**BEST STREAM AND WETLAND RESTORATION PROJECT
MONITORING REPORT
MONITORING YEAR 4
FINAL**

DUPLIN COUNTY, NORTH CAROLINA
CONTRACT No. 004631 - PROJECT No. 95353
USACE Action ID No. 2012-01384 -NCDWR Project No. 13-0865

RE: Best Stream and Wetland Restoration Site: MY4 Monitoring Report (NCDMS ID 95353)

Listed below are comments provided by DMS on December 14, 2018 regarding the Best Stream and Wetland Restoration Site: Year 4 Monitoring Report and RES' responses.

2018 Best Site Groundwater Monitoring Gauge Hydrographs

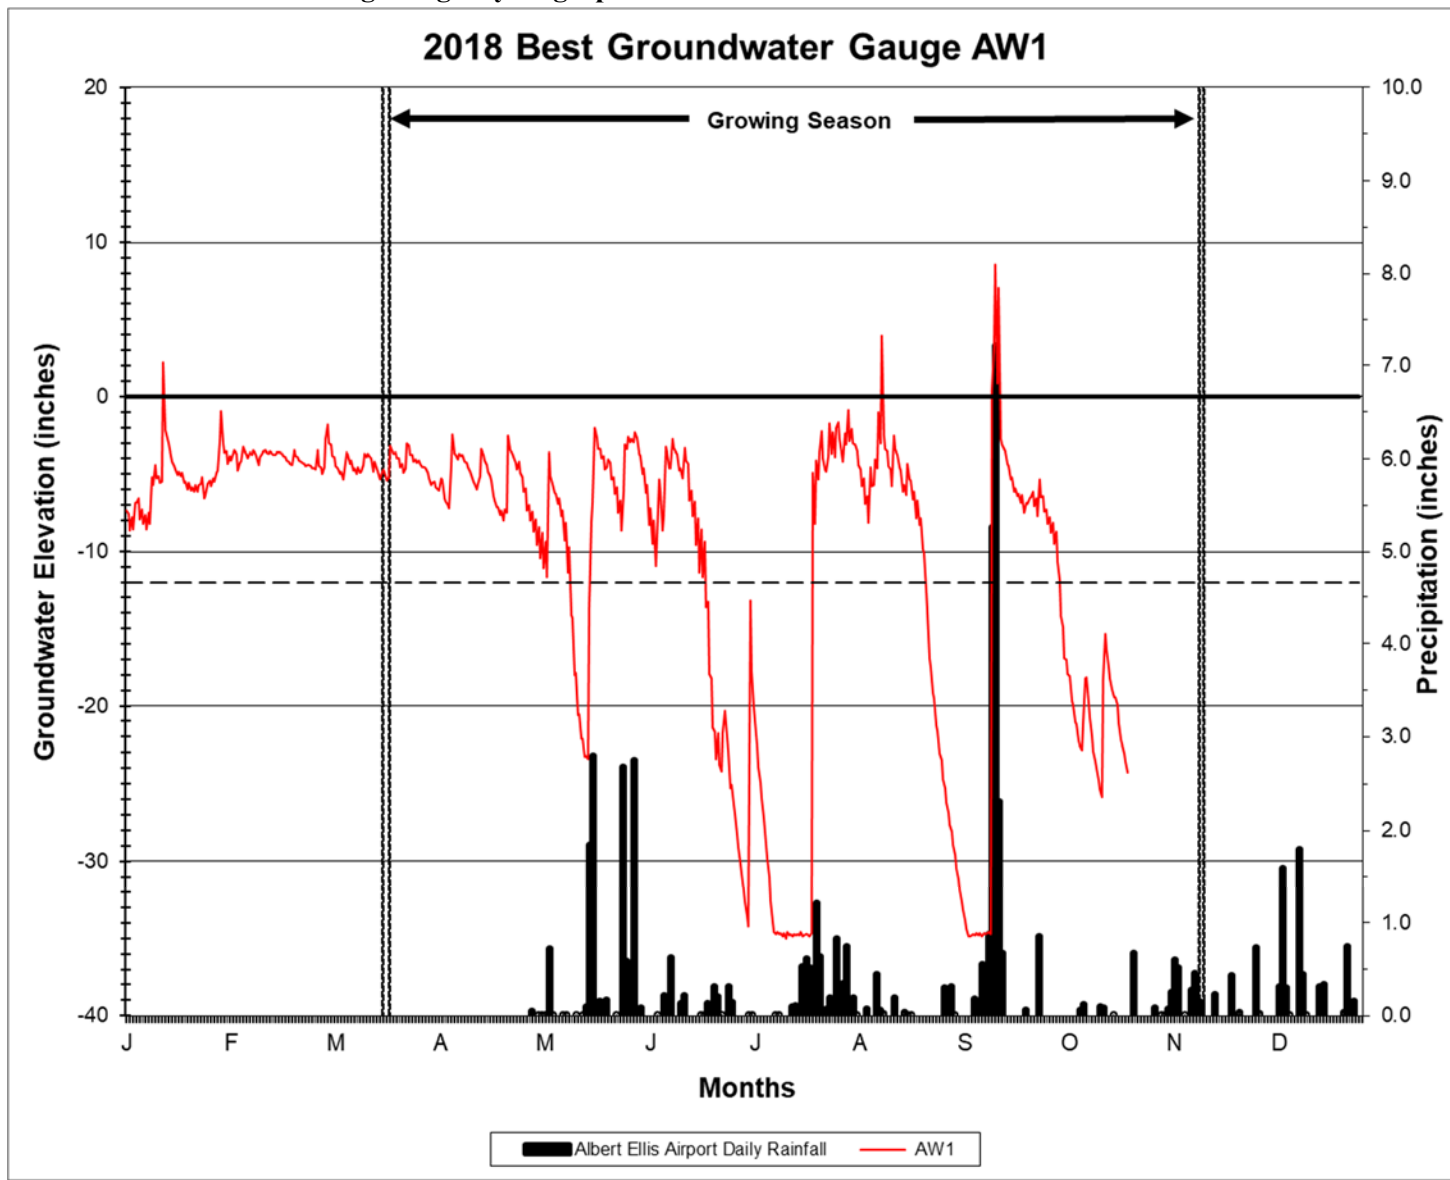
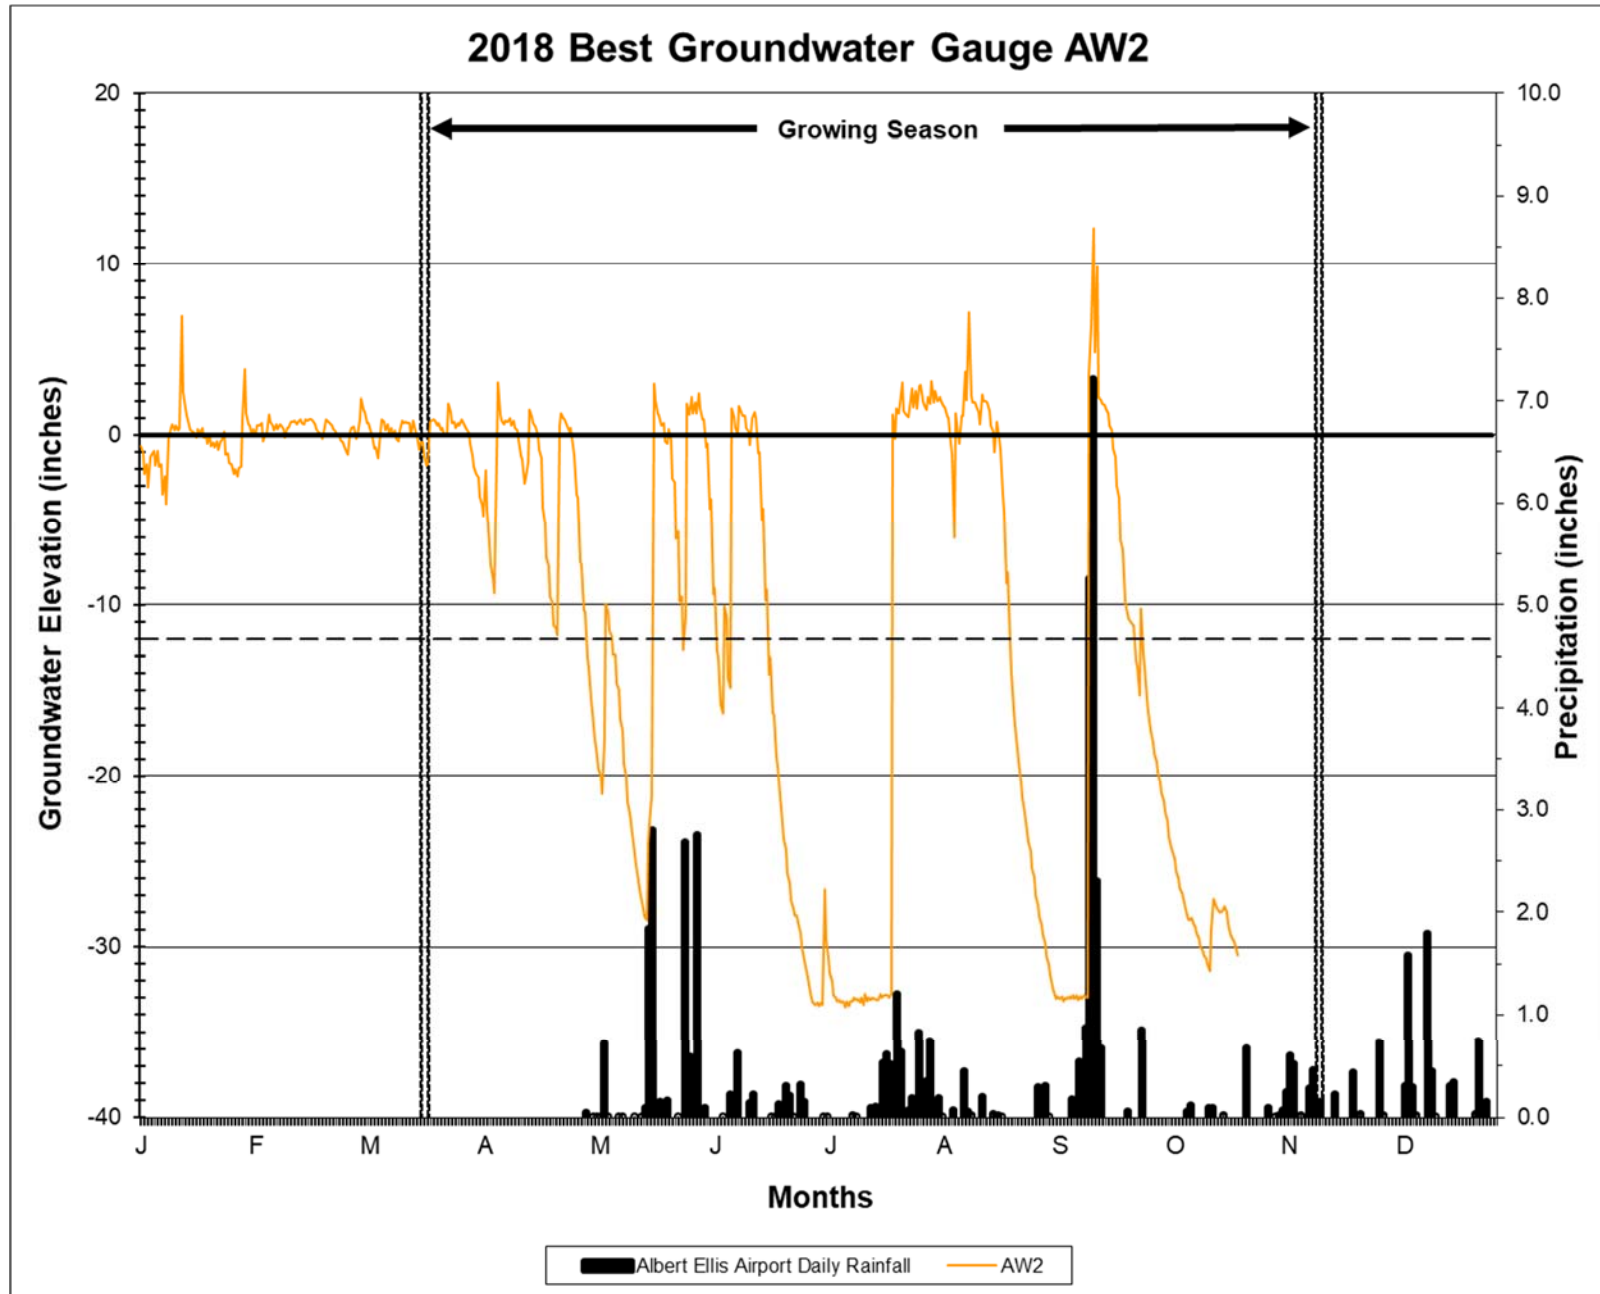
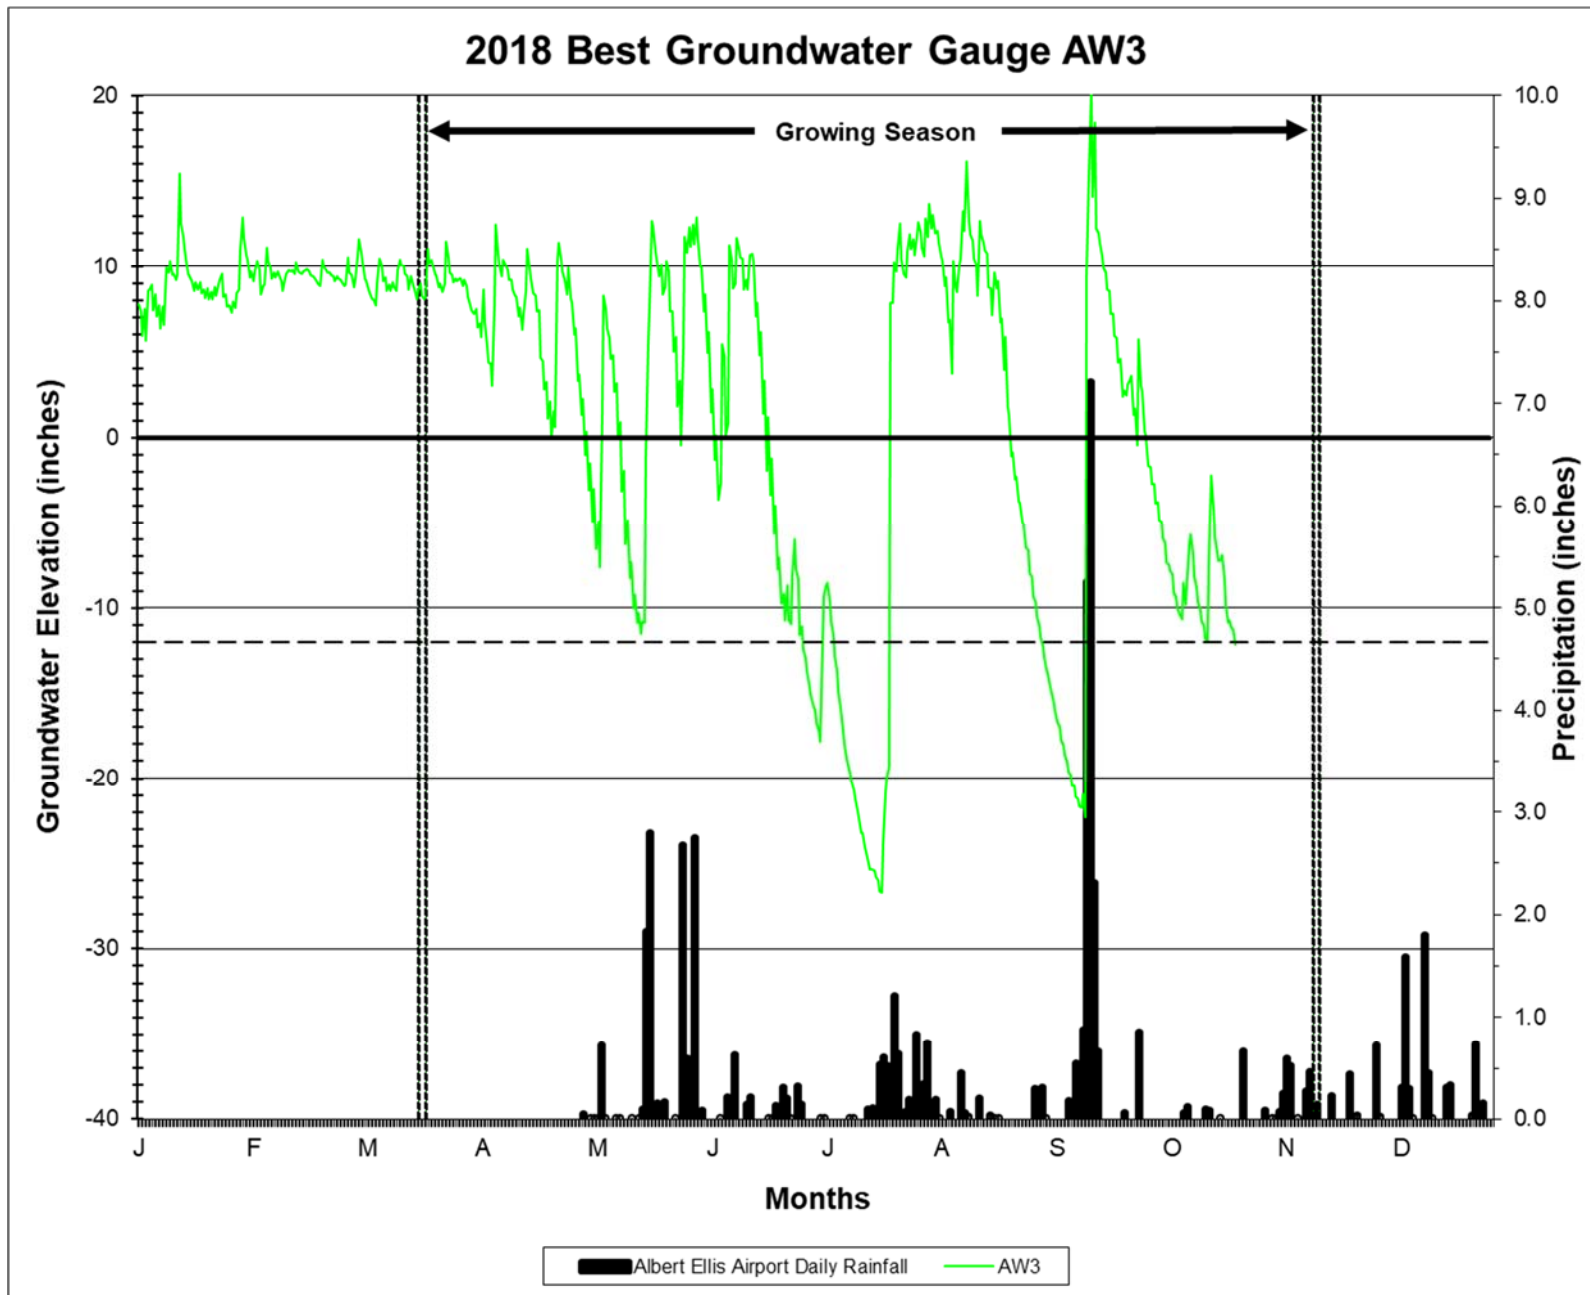
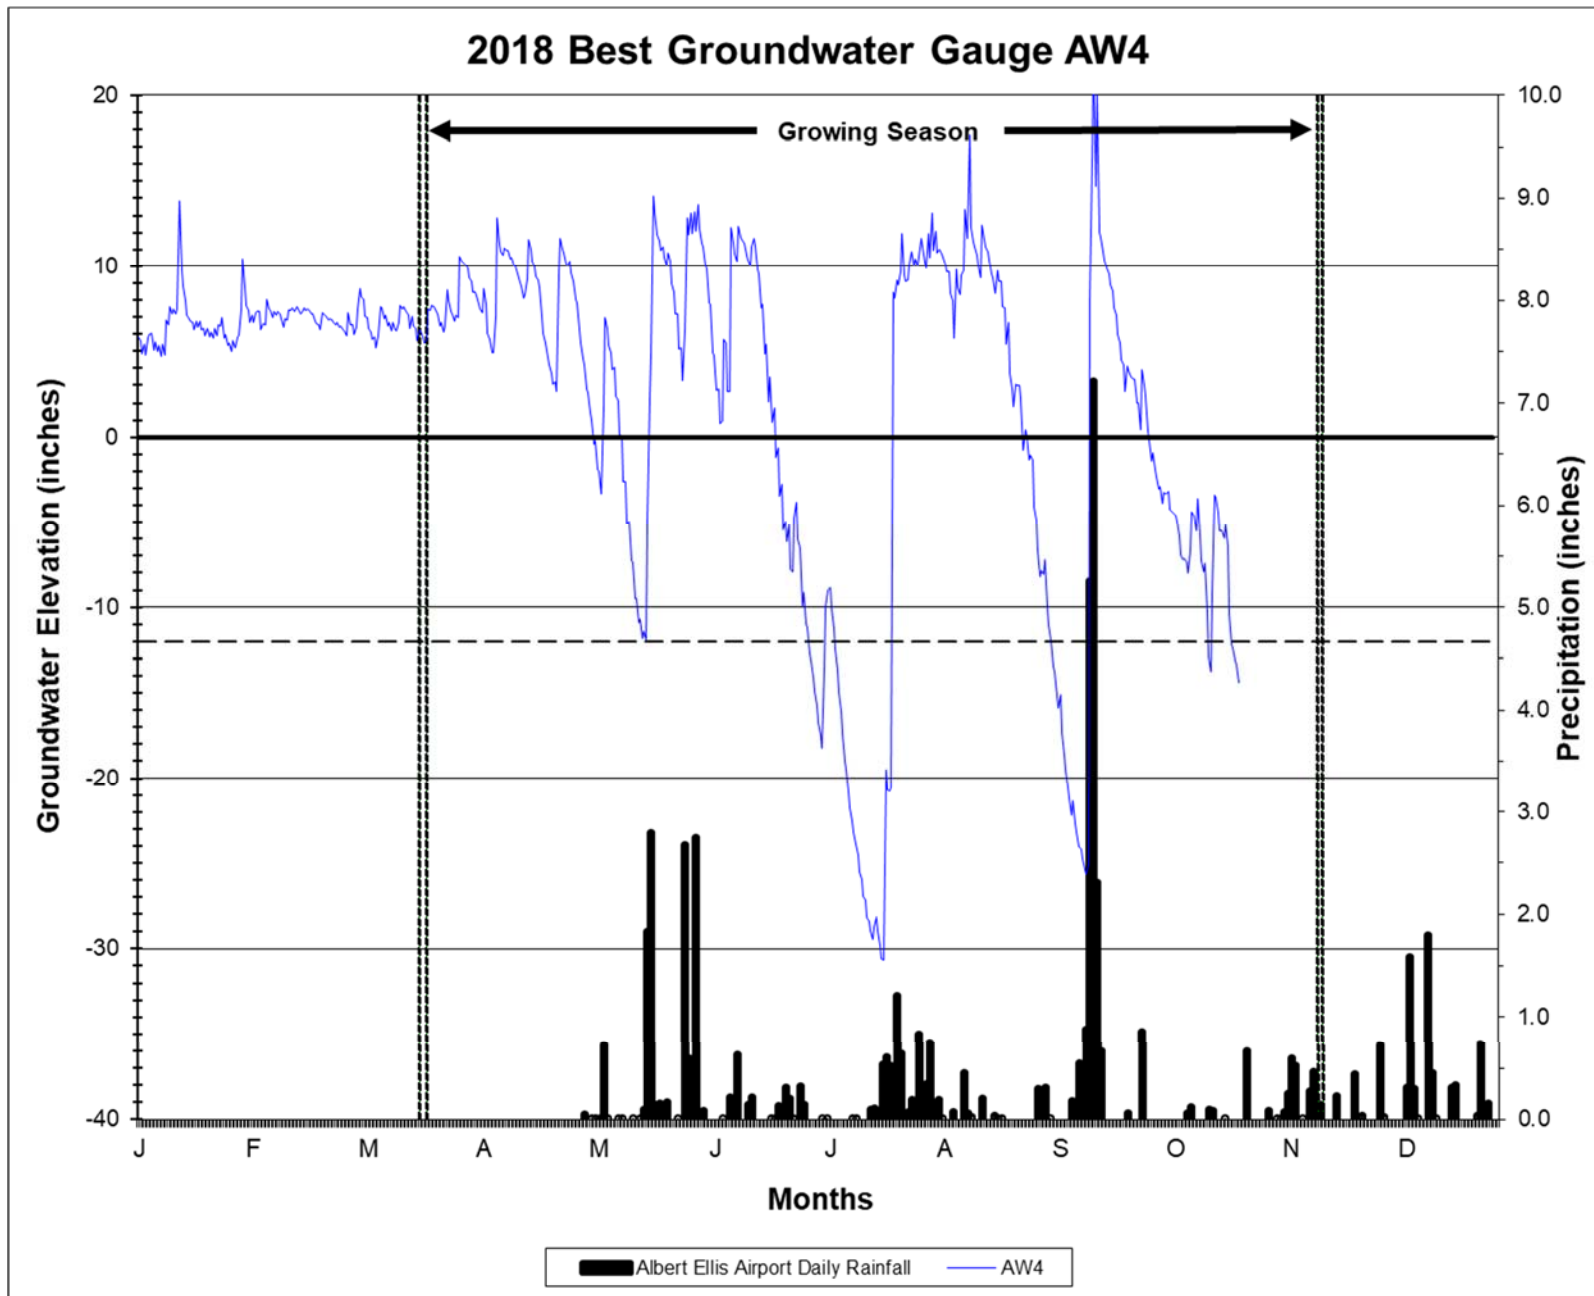
8. **Appendix E:**
2018 Groundwater Monitoring Gauge Hydrographs: In reviewing these hydrographs, it appears that the entire growing season was not observed for the wetland assessment/gauge data collection. Please explain why not.
[The wetland assessment/gauge data only represents 91% of the growing season because the last monitoring site visit for 2018 was October 24. Despite missing data from the last 22 days of the growing season, all wetland gauges met the success criteria.](#)
Verify rainfall data for September. Looks low based on impacts from Hurricane Florence.
[The Albert Ellis Airport rain gauge malfunctioned during Hurricane Florence. More accurate rain data from the Williamsdale Field Lab was used to supplement the Albert Ellis Airport rain data.](#)
